T J Booth Associates. Consulting Engineers 20A Eastgate St, Rochdale OL16 1DH	Project GB Services - Riverside Business Park (Proposed Unit 3)				Job Ref. rep-tjba-GBS-riverside business park-units 3- LLFA CONSULTATION RESPONSE-	
	Section LLFA Consultation Response				Sheet no./rev. 1 / 0	
	Calc. by DS	Date 23/06/2025	Chk'd by	Date	App'd by	Date

LLFA consultation dated 15th May 2025, ref: 25.00128.DOC Riverside Motors - Drainage Comments.

TJBA Response:

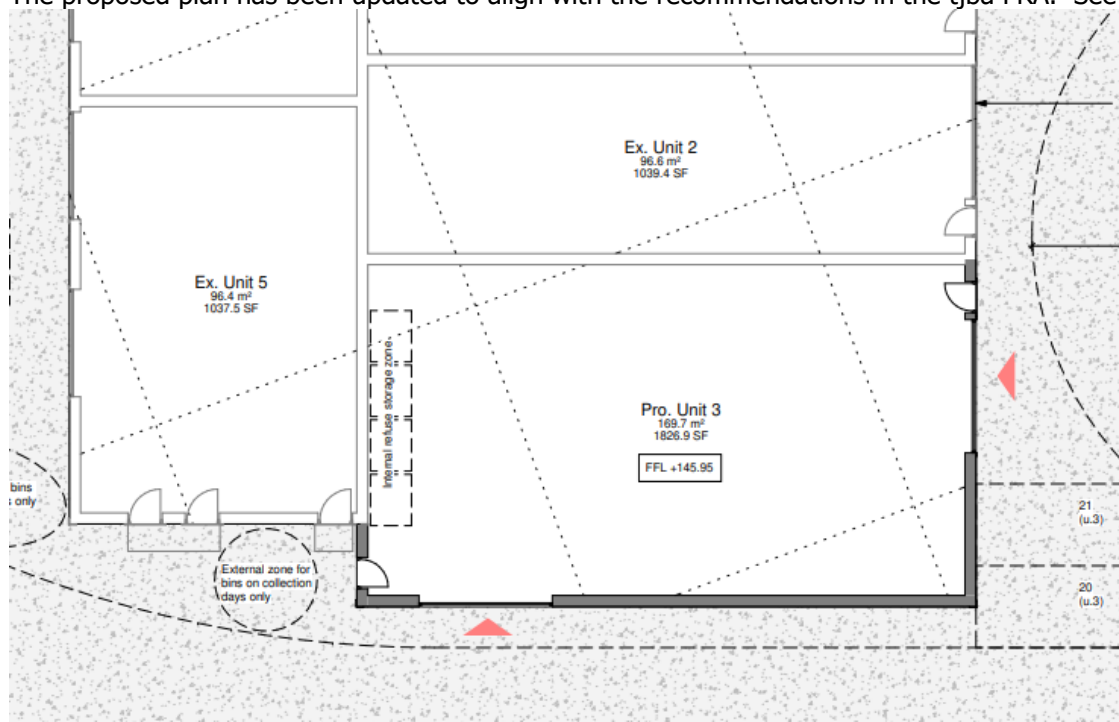
- Clarify / confirm that FFLs are 145.95 minimum in accordance with the FRA.
- The condition requires the submission of a maintenance plan.
- The above points should be addressed before the application is approved.

Please refer to full drainage design plan ref: dwg-tjba-GBS-riverside business park-drainage plan & details-rev1.

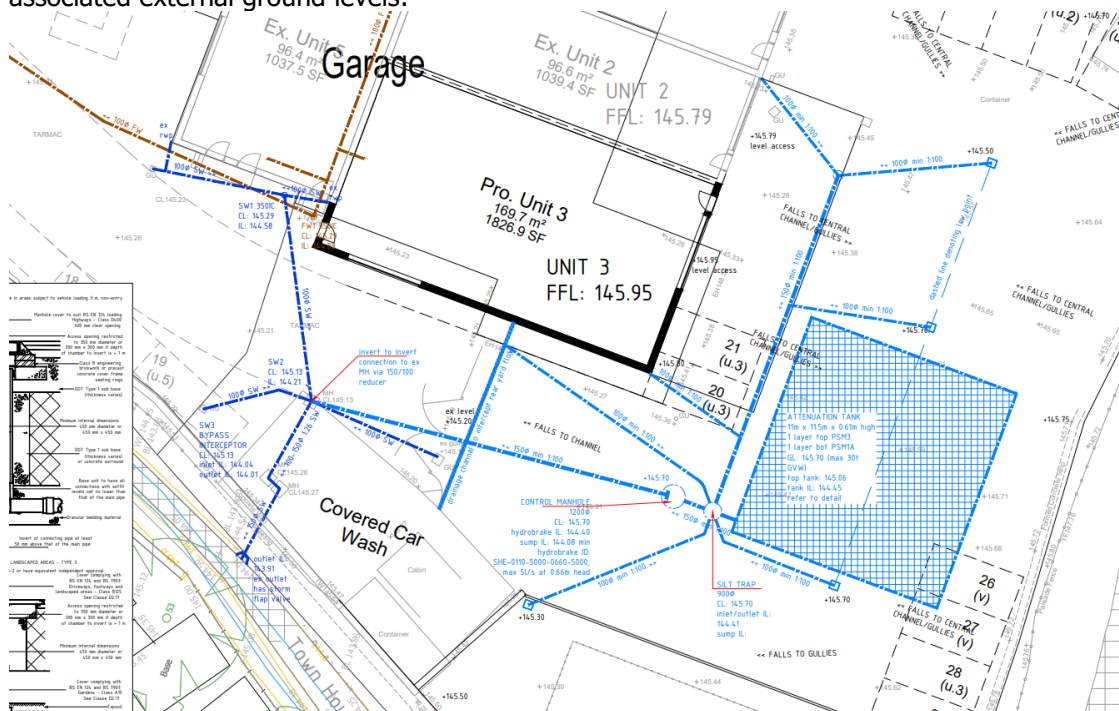
I. Clarify / confirm that FFLs are 145.95 minimum in accordance with the FRA.

The proposed plan has been updated to align with the recommendations in the tjba FRA. See below:
